This is to certify that BARTLETT CHRISTOPHER T / Glendale Construction Corp  
has permission to Replace bank of window, 3 non historical  
AT 18 TAYLOR ST CBL 057 B008001

# City of Portland, Maine - Building or Use Permit Application

**Dept:** Historic      **Status:** Approved with Conditions      **Reviewer:** Scott Hanson      **Approval Date:** 02/25/2010**Note:** 1-22 Went to look at windows in question. Clearly visible from the public way. HP review and approval required.      **Ok to Issue:** ☒

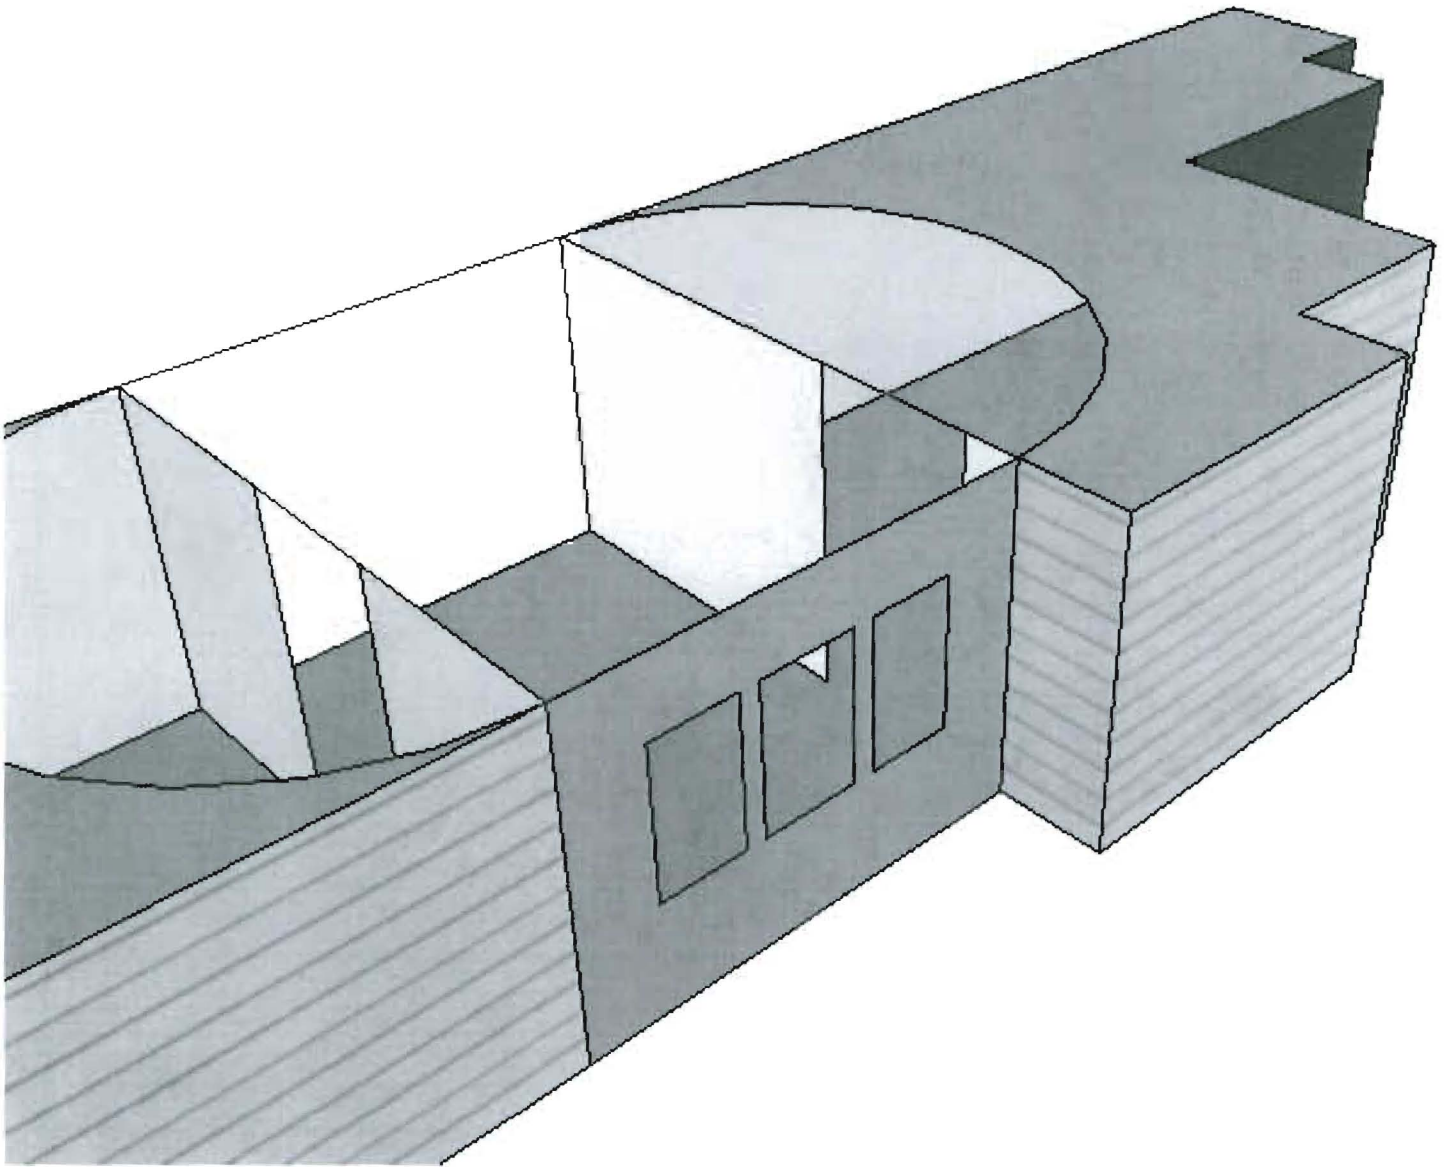
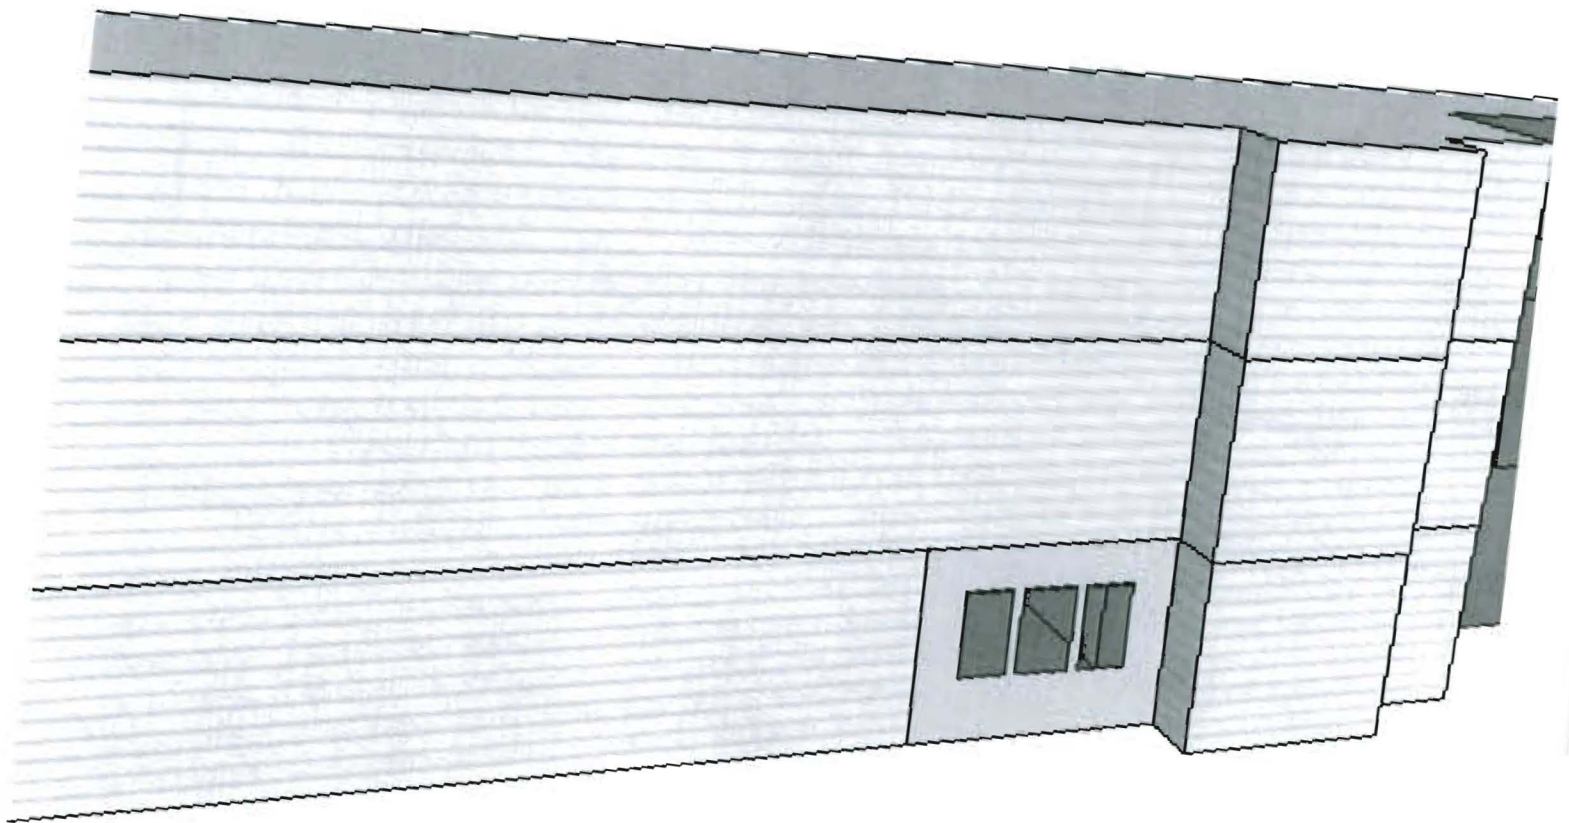
Thanks for the return call. If you could clarify on a floor plan where these windows are located. Also, there are several photos and it is confusing as there seems to be 2 different buildings.

You said this is in the bottom left unit, is this bowing affecting the wall in other floors as well?

The yellow highlighted area shows where the 3 windows are, view the file from the street looking at the left & front of the building.

First floor left most unit. The 3 windows just to the rear of the bay window area.

Some of the sketches show just the first floor unit but there is only one building.

We do not know what is causing the bowing, but it does not seem to be affecting the other units. Once the wall is exposed we will be able to determine this.

My hope is that the bowing is superficial, or specific to the bank of windows. But we do not assume such and included the possibility that a structural member might be required as a heads up to the city and the owner.
